RICHARDSON HALL CHILLER AND CONTROLS REPLACEMENT CM/GC

PROJECT NUMBER: 223923

ADDENDUM NO. 2

Richardson Hall HVAC Upgrades

Figure 4: Richardson/Peavy Hall Condenser Water System

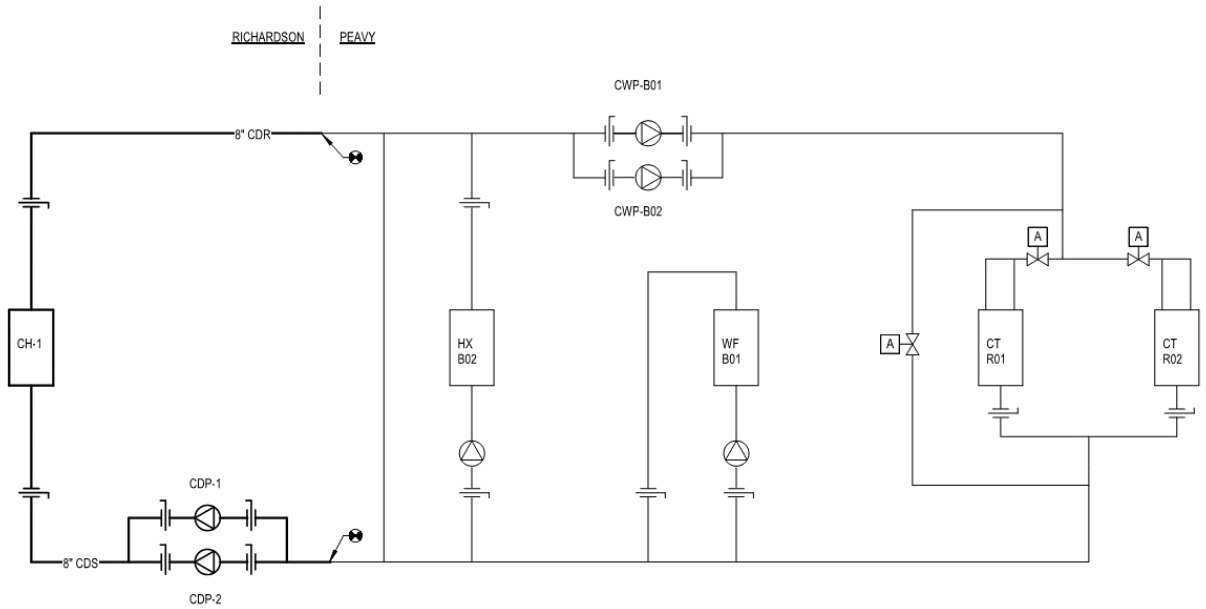
The condenser water piping system will be replaced within the Richardson Hall chiller room for the new chiller layout. The condenser water piping connecting to the Peavy Hall condenser water system will remain. See Figure 4 below.

The existing condenser water pump is past its expected service life and should be replaced with two base-mounted condenser water pumps. Each pump will be sized for 100% of the condenser water flow for redundancy.

Figure 3 Richardson Hall Chilled Water Diagram

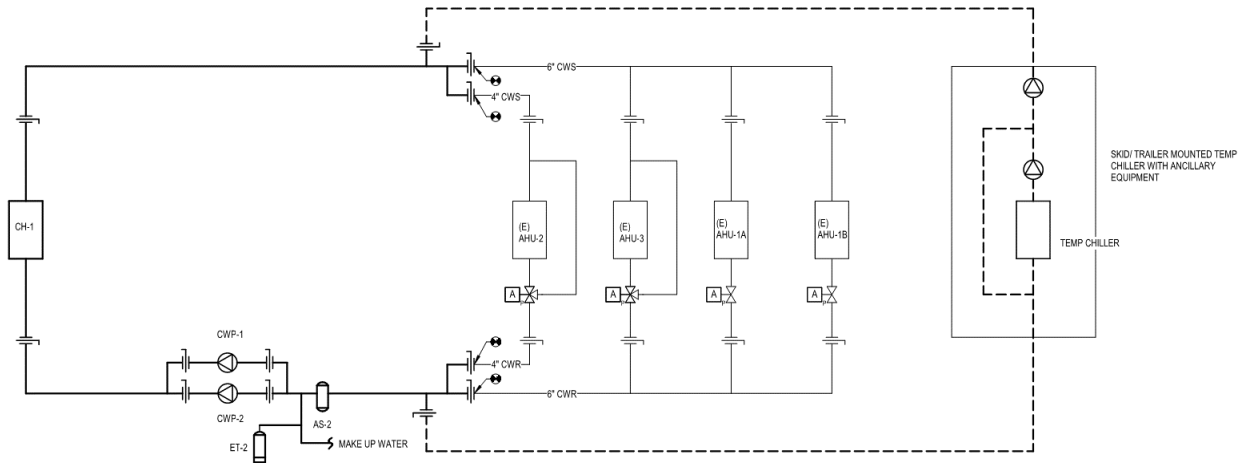
The primary-secondary chiller system will be replaced with a variable volume primary only cooling system. Three-way control valves on air handlers AHU-2 and AHU-3 will maintain the minimum flow through the chillers. See Figure 3 below.

New 6-inch diameter chilled water supply and return piping will be provided for connecting to a temporary air-cooled chiller.

- Chilled water piping will be Schedule 40 ASTM A53 steel with mechanical couplings.

Figure 4 Richardson/Peavy Hall Condenser Water System

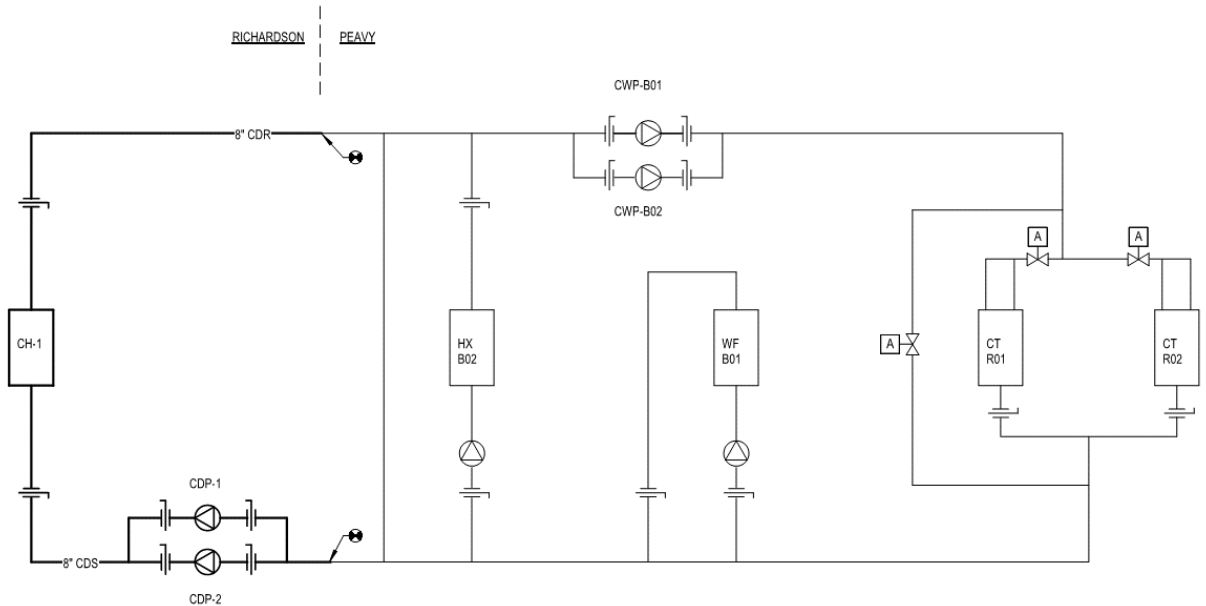
The condenser water piping system will be replaced within the Richardson Hall chiller room. Condenser water piping connecting to the Peavy Hall condenser water system will remain. See Figure 4 below.

The 8-inch diameter condenser water supply and return piping will be replaced throughout the Richardson Hall chiller room. New 8-inch condenser water supply and return piping will connect to the existing piping at the north wall of the chiller room.

- Piping will be Schedule 40 ASTM A53 steel with mechanical joints.
